BURLINGTON SUBDIVISION, PHASE I

APPLICATION NUMBER 11 DATE January 7, 2016

APPLICANT Burlington Subdivision, Phase I

REQUEST Subdivision

DETAIL SITE PLAN

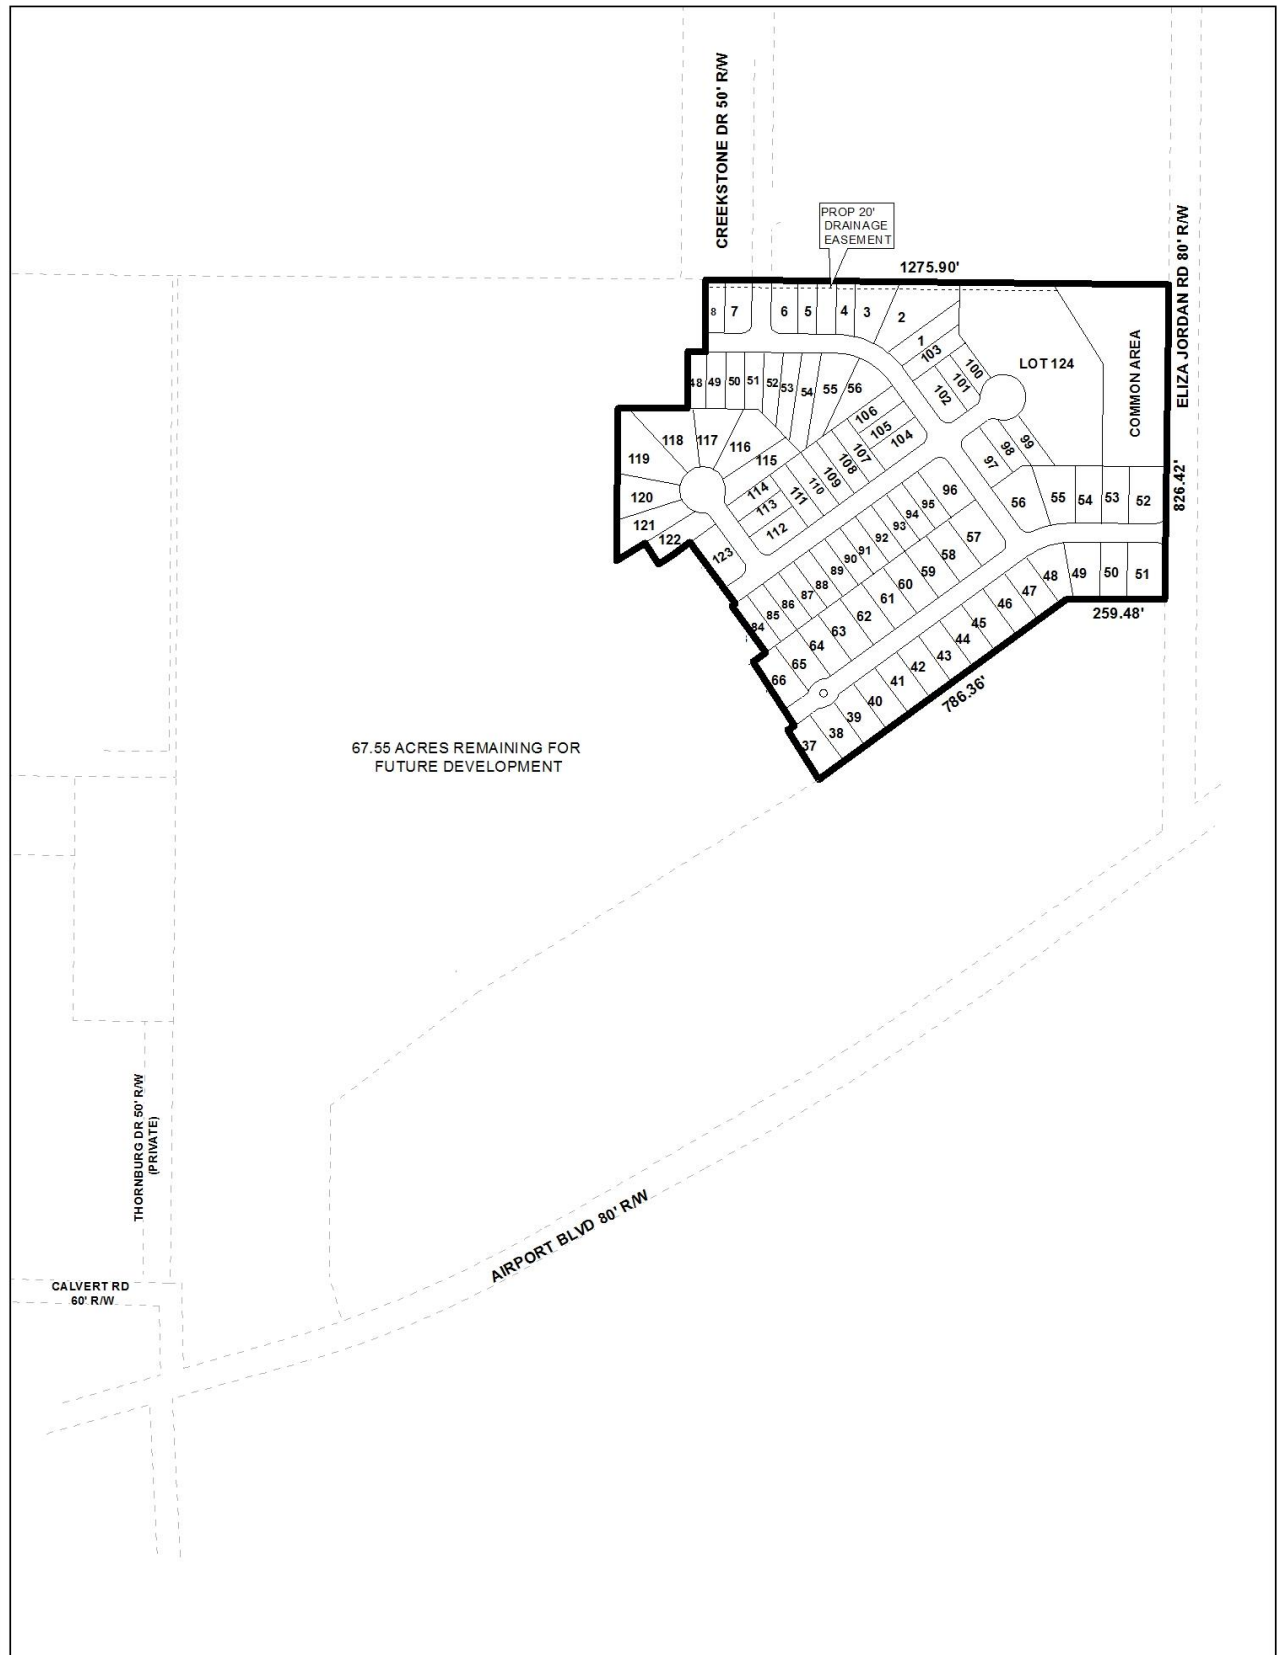
The site fronts Eliza Jordan Road South which is a component of the Major Street Plan with a planned 100' right-of-way. As the current right-of-way width along Eliza Jordan Road South is 80', dedication sufficient to provide 50' from the centerline of Eliza Jordan Road South would be required. The 25' minimum building setback line is not indicated along the existing frontage of Eliza Jordan Road South or any of the proposed lots. Therefore, the plat should be revised to illustrate the 25' minimum building setback line along all street frontages and measured from any required dedication along Eliza Jordan Road South.

Access management is a concern along Eliza Jordan Road South; therefore, a note should be required on the Final Plat, if approved, stating that Lots 51, 52 and the Common Area are denied access to Eliza Jordan Road South. The plat does not indicate any designated access to the Common Area; therefore, dedicated access within the Subdivision should be provided to the Common Area. All lots and the Common Area should be limited to one curb cut each, with the size, location and design to be approved by Mobile County Engineering.

No lot areas are indicated on the preliminary plat. The plat should be revised to label each lot with its size in both square feet and acres, or a table should be furnished on the Final Plat providing the same information.

The size of Lots 51 and 52 should be indicated after any required frontage dedication along Eliza Jordan Road South.

Section V.D.2. of the Subdivision Regulations establishes minimum lot dimensions and areas. The plat indicates that many of the proposed lots are of substandard width (less than 60' wide at the building setback line) and/or of substandard size (less than 7,200 square feet). Many of the lots are only 50' wide at the building setback line and some contain as little as 7,000 square feet. And Section V.D.3. states that the depth of lots shall not be more than 3.5 times the width of the lot at the building setback line. Several of the lots exceed the allowable ratio. However, the original approval of the Burlington & Sierra Master Plan Subdivision was based on the applicant submitting justification as an innovative Subdivision allowing for such reductions as in other similar Subdivisions in the Jurisdiction. The currently proposed lot configurations are the same as in that original approval and waivers of Sections V.D.2. and V.D.3. would be in order.

A drainage easement associated with the Common Area is indicated along the North boundary of the Subdivision. Therefore, a note should be placed on the Final Plat stating that no structures may be constructed or placed within any easement.

The site has closed-end streets that exceed 600 feet. Thus, a waiver of Section V.B.6 of the Subdivision Regulations would be required. The plat indicates compliant turnaround right-of-way diameters of 120 feet for cul-de-sacs and this should be retained on the Final Plat, if approved. Street stubs to the Future Development area should be revised to provide temporary turnarounds. There are no closed end streets which contain thirty or more lots and the site has two points of access; therefore, compliance with Appendix D of the IFC is satisfied.

The site has property lines at an intersection corner. Section V.D.6. of the Subdivision Regulations requires that *"property lines at street intersection corners shall be arcs having radii of at least 10 feet or shall be chords of such arcs."* The plat should be revised to label the curb radii onto Eliza Jordan Road South meeting this requirement.

- 1) recording of the Eliza Jordan Center Subdivision prior to the signing of the Final Plat;
- 2) dedication sufficient to provide 50' from the centerline of Eliza Jordan Road South;

- 3) revision of the plat to indicate the 25' minimum building setback line along all street frontages and measured from any required dedication along Eliza Jordan Road South;

- 4) placement of a note on the Final Plat stating that Lots 51, 52 and the Common Area are denied access to Eliza Jordan Road South;
- 5) revision of the plat to provide dedicated access to the Common Area from within the Subdivision;

- 6) placement of a note on the Final Plat stating that all lots and the Common Area are limited to one curb cut each, with the size, location and design to be approved by Mobile County Engineering;

- 7) revision of the plat to label each lot with its size in both square feet and acres, or the furnishing of a table on the Final Plat providing the same information;

- 8) the indication of the sizes for Lots 51 and 52 after any required frontage dedication along Eliza Jordan Road South;
- 9) placement of a note on the Final Plat stating that no structures may be constructed or placed within any easement;

- 12) revision of the plat to provide temporary turnarounds on the street stubs to the Future Development area;
- 13) revision of the plat to indicate street intersection curb radii in compliance with Section V.D.6. of the Subdivision Regulations along Eliza Jordan Road South;
